See the changes I need made below. Also, see the project files attached for the Gerber and Eagle files for this project.

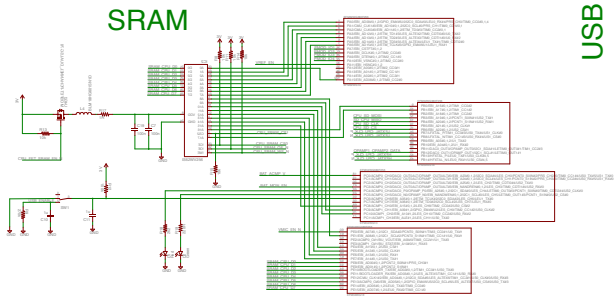
Don't use a battery holder. Instead leave 2 thru-holes (positive and negative) that will solder/ connect to a 6v external battery pack

Don't use a mic. Instead provide thru-holes to allow for soldering/connecting a 3 wire preamplified external microphone that runs on 3.3v power (wire 1 is 3.3v power, wire 2 is signal, and wire 3 is ground)

Make the preamp 0dB fixed gain, maybe it is already?

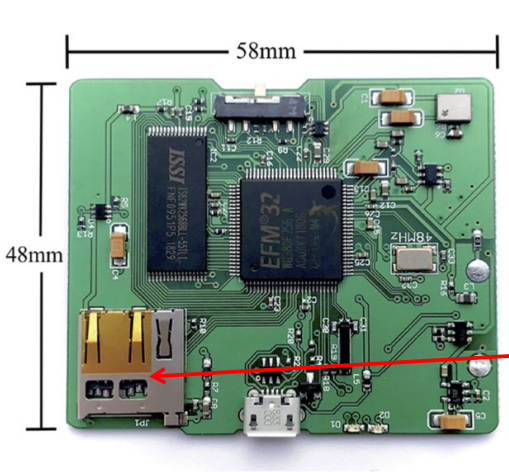
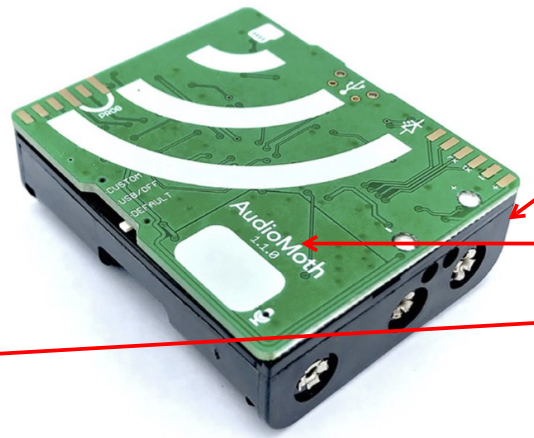
Change to use (10) microSD cards instead of (1). Unit should fill up 1 card and then move to the next as it fills each card up.

REMOVE BATTERY HOLDER. INSTEAD LEAVE THRU-HOLES TO SOLDER ON A EXTERNAL BATTERY PACK WIRE LEADS

REMOVE SILKSCREEN LOGO SHOWN ON THE BACKSIDE. INSTEAD JUST SAY "1.0.0"

EXTEND BOARD LONGER AS REQUIRED TO FIT ALL THE SD CARD SLOTS
(Place card holders on both sides of board)
